HISTORIC AND DESIGN REVIEW COMMISSION

November 06, 2019

HDRC CASE NO: 2019-644
ADDRESS: 232 FLORIDA ST
LEGAL DESCRIPTION: NCB 3009 BLK 7 LOT 8-9
ZONING: RM-4, HS, H
CITY COUNCIL DIST.: 1
DISTRICT: Lavaca Historic District
LANDMARK: House
APPLICANT: Monday Construction
OWNER: Steckly/Robison
TYPE OF WORK: Windows/fenestration changes
APPLICATION RECEIVED: October 10, 2019
60-DAY REVIEW: December 09, 2019
CASE MANAGER: Huy Pham
REQUEST:

The applicant is requesting a Certificate of Appropriateness for approval to perform the following fenestration modifications to the rear addition:

232 FLORIDA

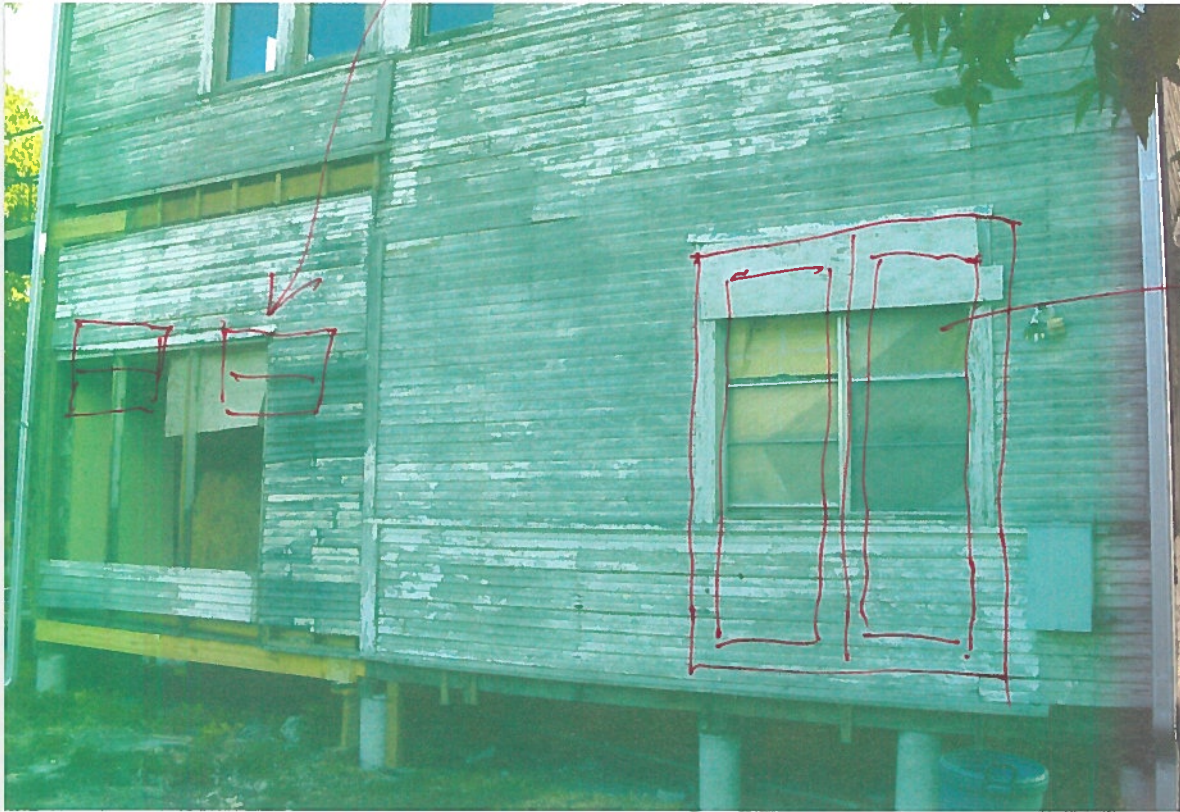
- c. EAST ELEVATION WINDOWS – The applicant has proposed to replace two ganged aluminum windows with wood windows of the same opening size and sash configuration. Per the Guidelines for Additions 4.A.ii., staff finds that the proposed window replacement would be an improvement to the existing condition of the addition and is generally appropriate if the window installation meets the Standard Specifications for Window Replacement.

- d. EAST ELEVATION DOOR – The applicant has proposed to replace the solid door and aluminum screen door with a full-lite door. Per the Guidelines for Additions 4.A.ii., staff finds that the proposed window replacement would be an improvement to the existing condition of the addition and is generally appropriate.

- e. SOUTH ELEVATION WINDOWS – The applicant has proposed to replace three missing aluminum windows with two smaller wood windows. Per the Guidelines for Additions 4.A.ii., staff finds that the three window openings should be maintained in size and location as it relates to the existing fenestration pattern and sizes of window openings on the historic portions of the structure. However, the proposed window replacement would be an improvement to the existing condition of the addition and is generally appropriate if the window installation meets the Standard Specifications for Window Replacement., noted as follows: A wood window should be installed that features meeting rails that are no taller than 1.25” and stiles that are no wider than 2.25”. White manufacturer’s color is not allowed, and color selection must be presented to staff. There should be a minimum of two inches in depth between the front face of the window trim and the front face of the top window sash. This must be accomplished by recessing the window sufficiently within the opening or with the installation of additional window trim to add thickness. Window trim must feature traditional dimensions and architecturally appropriate sill detail. Window track components must be painted to match the window trim or concealed by a wood window screen set within the opening.

- f. SOUTH ELEVATION DOOR- The applicant has proposed to replace two ganged aluminum windows with double full-lite doors. Per the Guidelines for Additions 4.A.ii., staff finds that the proposed window replacement with doors would be an improvement to the existing condition of the addition and is generally appropriate if the width and location of the existing window opening is maintained.

- i. That all new windows meet the Standard Specifications for Replacement Windows
- ii. That all window opening sizes and locations are maintained. For Item 3., the three window openings may be replaced with a wood product of the same quantity, size, and location rather than converting to two smaller windows. For Item 4., the two ganged windows may be replaced with double-doors with the same width and location of the existing opening.

- i. That the proposed windows feature the following stipulations: Meeting rails must be no taller than 1.25” and stiles no wider than 2.25”. White manufacturer’s color is not allowed, and color selection must be presented to staff. There should be a minimum of two inches in depth between the front face of the window trim and the front face of the top window sash. This must be accomplished by recessing the window sufficiently within the opening or with the installation of additional window trim to add thickness. Window trim must feature traditional dimensions and architecturally appropriate sill detail. Window track components must be painted to match the window trim or concealed by a wood window screen set within the opening.
